**Response to the
November 20, 2017, and December 12, 2017
MDEP Information Requests**

New England Clean Energy Connect (NECEC)

Prepared for:
Maine Department of Environmental Protection

March 29, 2018

PHOTOSIMULATION 11: KENNEBEC GORGE Looking North, Moxie Gore, 3 Structure Option

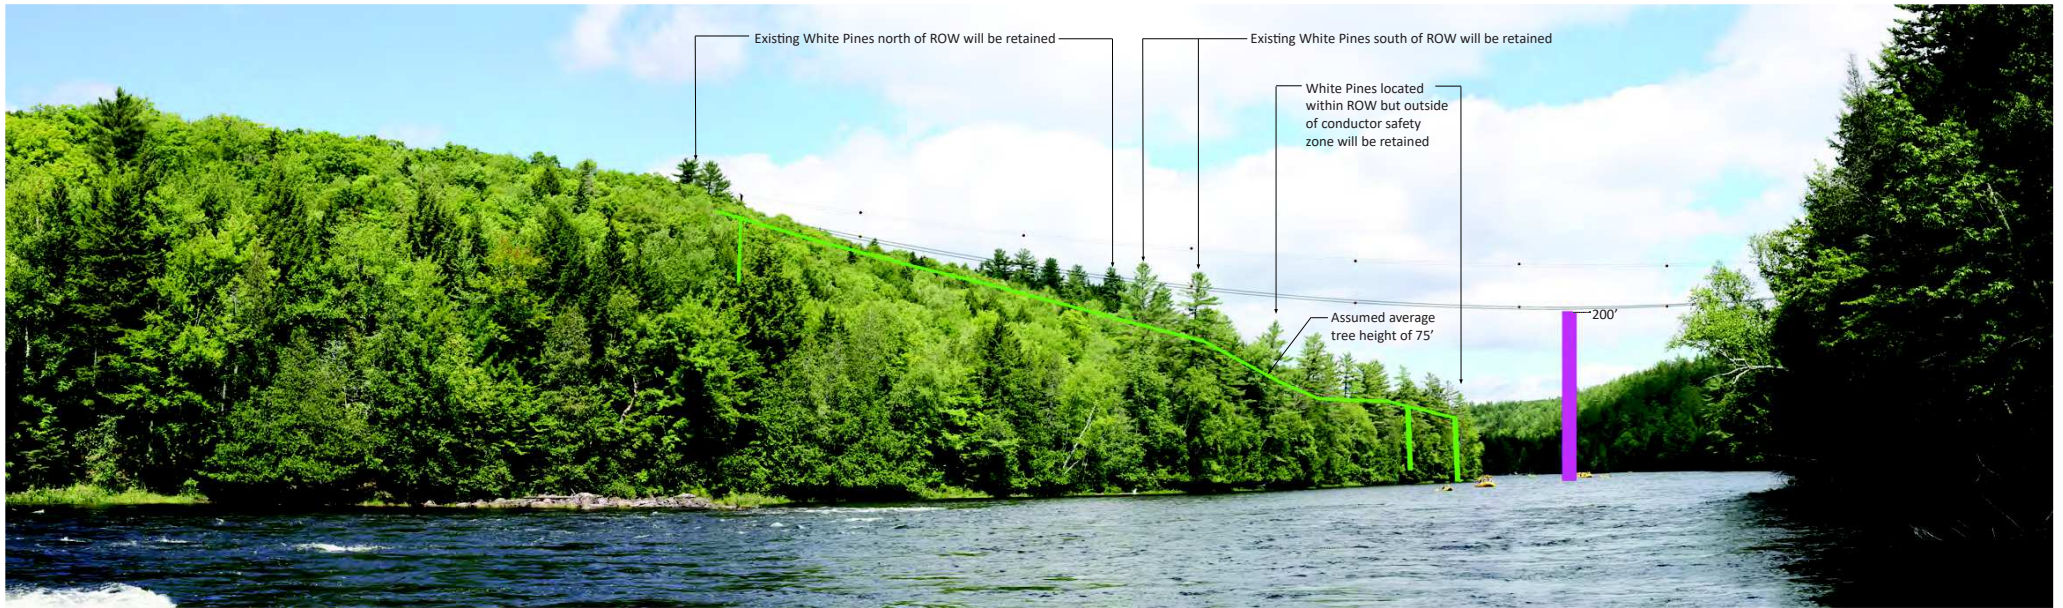
- 3. At the site visit on November 13, 2017 the applicant appeared to be working on a redesign of the crossing which would reduce the number of structures near the Kennebec River, elevate the conductors farther above the river, increase the undisturbed buffer along the river. Please provide the new design as soon as possible and include photosimulations which show the view looking directly into the corridor from the river. Also, quantify the vegetation that will need to be cut in the “buffer” area of the Gorge, both during construction and maintenance activities. The Department will need to have an understanding of the height of the conductors and the wire safety zone as well as the height of the capable vegetation that currently exists. If vegetation will be removed in this area (through maintenance activities) we need to evaluate that.**

CMP has since redesigned the Kennebec River Gorge crossing to increase and maximize the forested buffer on both sides of the river bank and to remove Structures 3006-21, 3006-22 and 3006-23 from the line of sight of users approaching the crossing point from upriver.

On the southeastern river bank approximately 300 feet of forested buffer will be maintained, with trees within this buffer at an average mature height of 75 feet. On the northwestern river bank approximately 550 feet of forested buffer will be maintained, with trees within this buffer also at an average mature height of 75 feet. At the centerline of the river, the conductor will be approximately 200 feet above the water level at maximum sag.

Advantages of the proposed 3-Structure design compared to the 5-Structure design include: fewer structures; greater vertical clearance over water; greater vertical clearance over trees; retention of trees over a larger area of forested buffer; and screened views of the transmission line structures and the cleared corridor from the perspective of river users.

CMP provided revised photosimulations and cross sections depicting the 3-pole structure redesign in an email to MDEP on December 12, 2017. Upon further conversations with LUPC, CMP is providing (attached to this submittal) revised photosimulations, dated January 22, 2018, of the 3-pole structure redesign, at a “normal view,” removing the distortion and providing a more accurate depiction of the conductor sag over the river. Additionally, the mark-up of the panoramic photos includes overlaid scale references and additional detail of the low point of the conductor sag and the assumed average of the 75-foot existing tree height. See Attachment A: Kennebec River Gorge Photosimulations.
